**EL PASO WATER
PURCHASING DEPARTMENT
1154 HAWKINS BLVD.
EL PASO, TEXAS 79925**

Customer Information System and Implementation Services

REQUEST FOR PROPOSAL NUMBER RFP04-18

ADDENDUM NUMBER 2

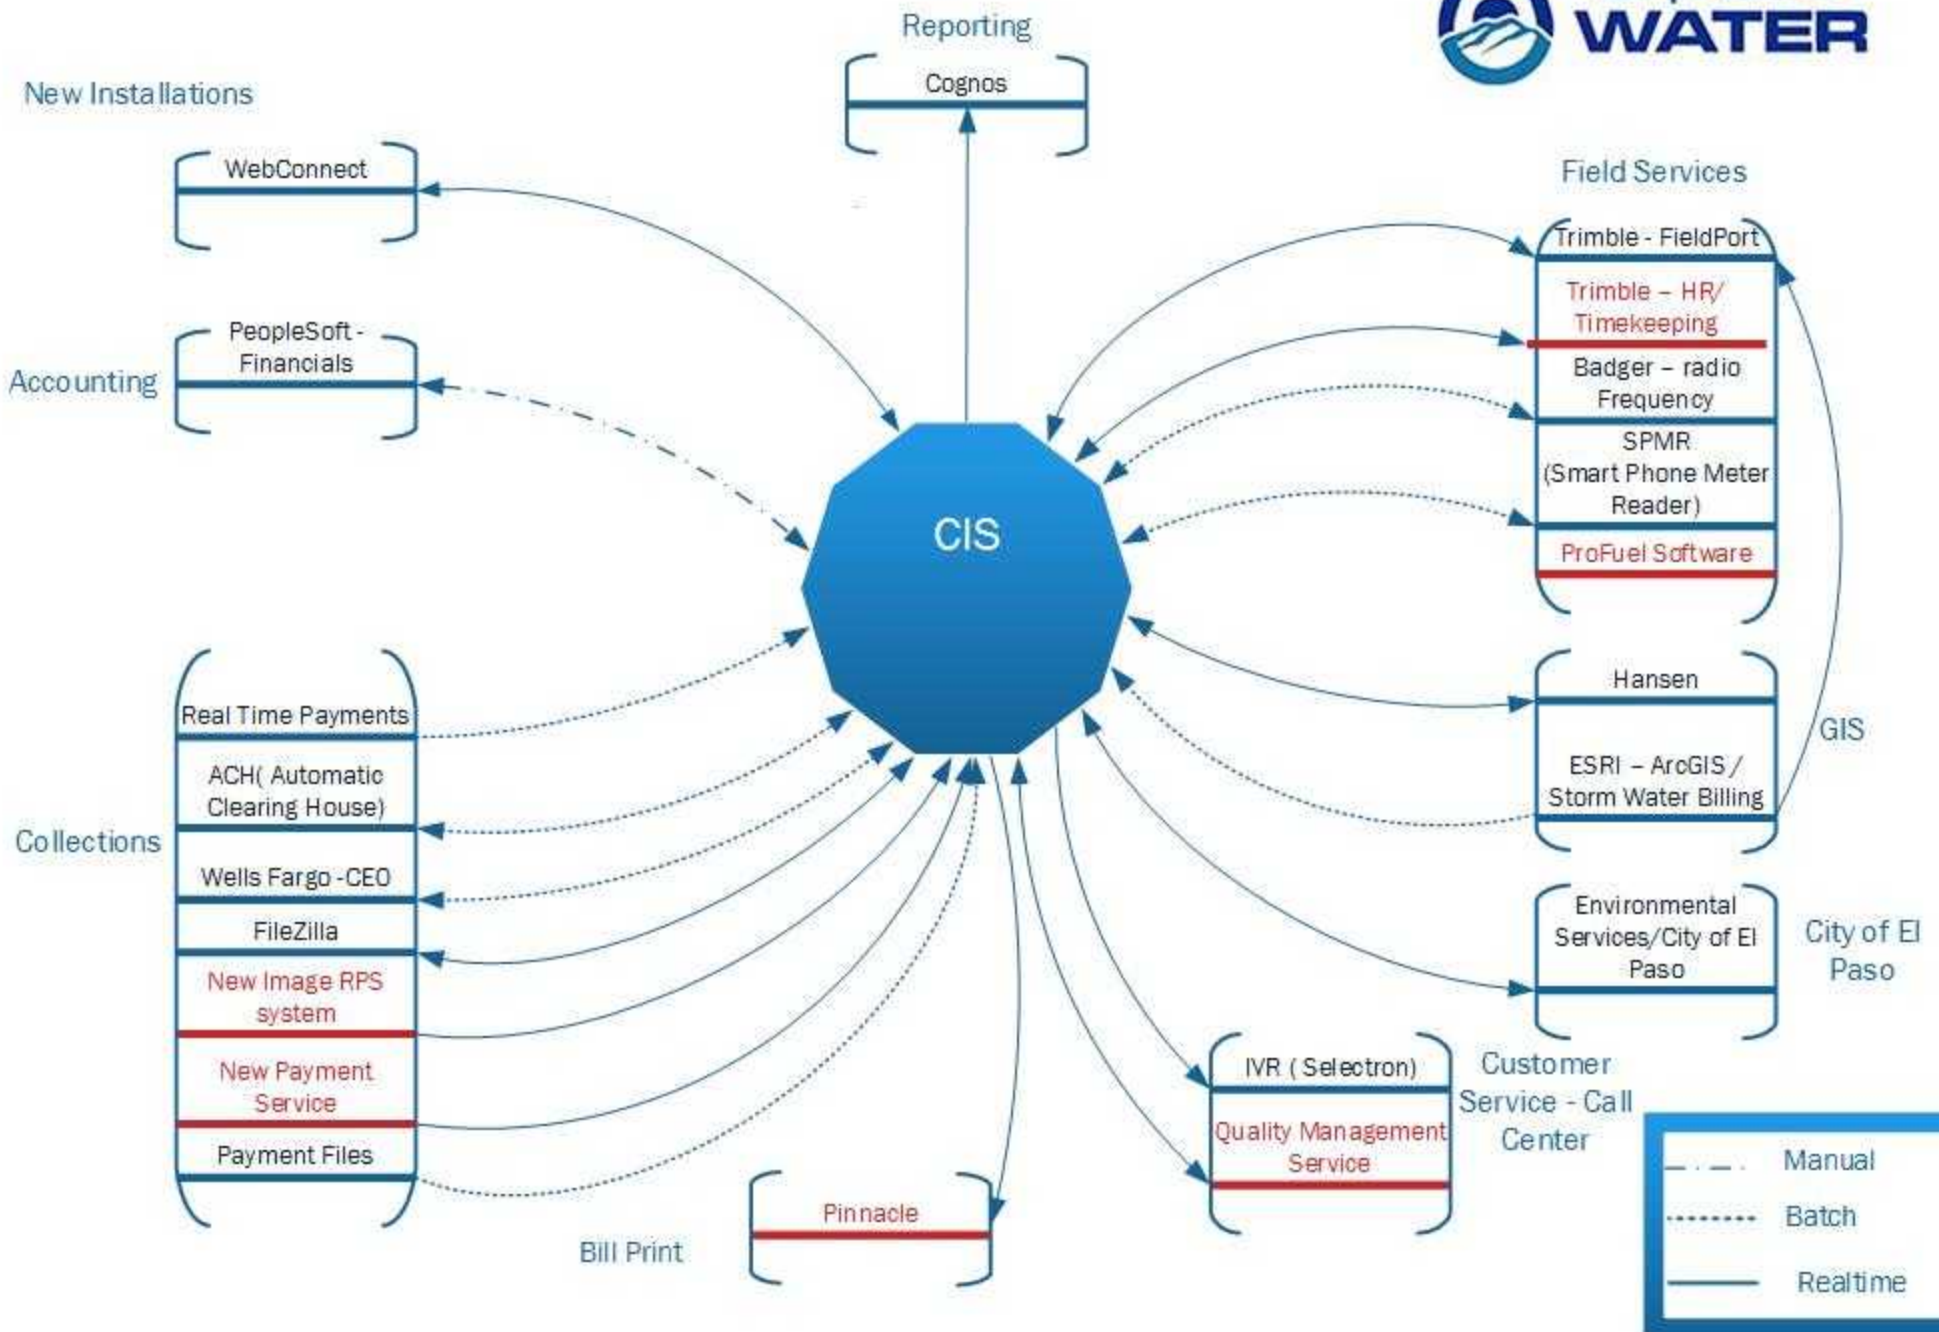
Delete current interface diagram and replace with attached updated interface diagram
